**REQUEST FOR INFORMATION      DATE:** December 27, 2016      **NO.:** RFI-391

Project Name: 15051-Webster University Interdisciplinary Science Building      Project No.: 15051

Subject: Short Throw Projector Elevations

## TYPICAL ELEVATION OF ULTRA SHORT THROW PROJECTOR

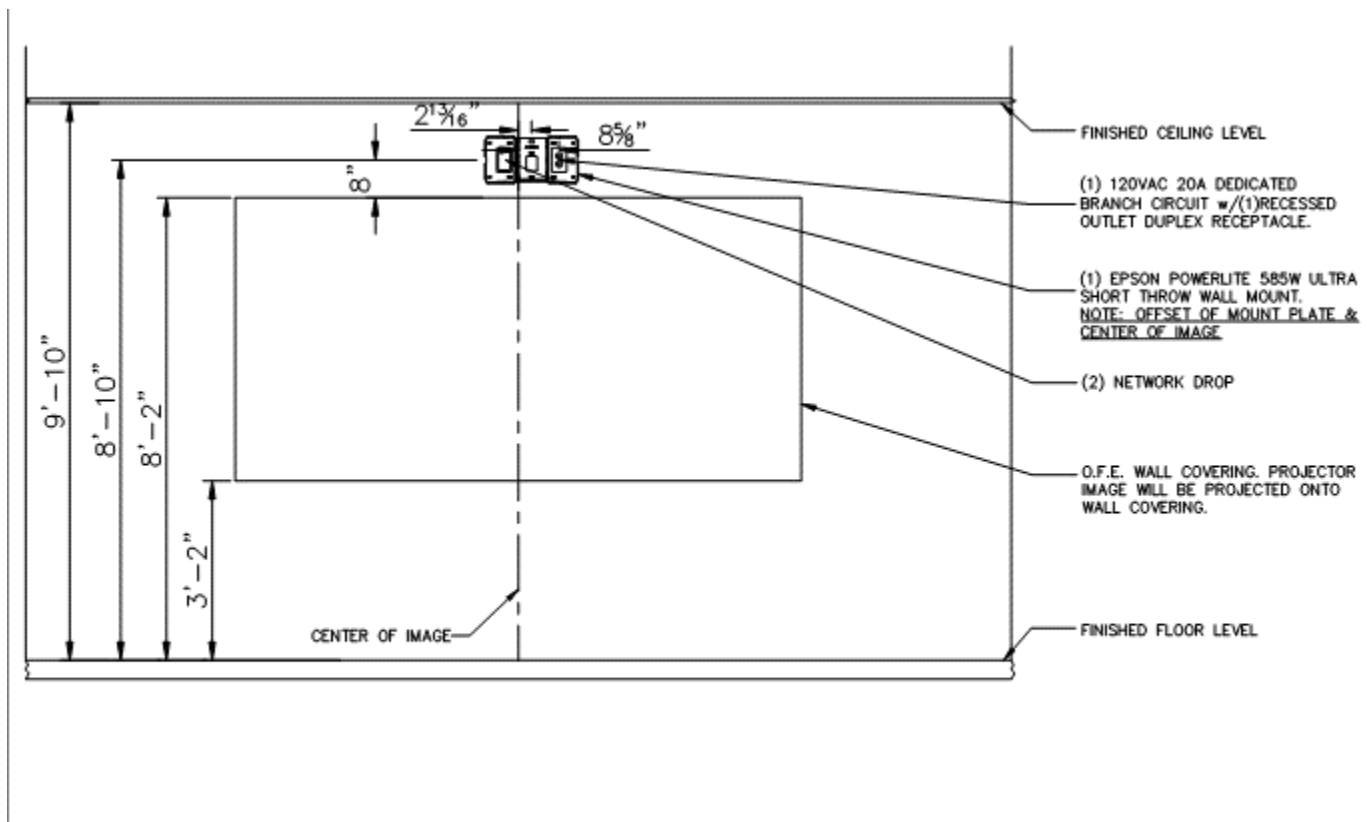
Detail 1 on page AV404 of the AV Infrastructure drawings shows a typical elevation of ultra short throw projector with a ceiling height of 9' 10". This is being used in rooms with a 9' 6" ceiling (health assessment lab 131 for example). The electricians are currently roughing in the center of the boxes at 8' 6" instead of 8' 10" as shown to accommodate for the 4" difference. Please advise asap if this is not acceptable.

Per attached email - 8'-10" is the correct dimension.

You are correct that the 8'10" height AFF is correct and needs to be maintained. Please let me know if myself or Tim needs to follow up with a more formal reply.

Attached is an RFI on the Short Throw Projector for some of the Level 1 Rooms: **Our understanding is that the 8'-10" box height is correct** as shown –. Please respond asap if possible.
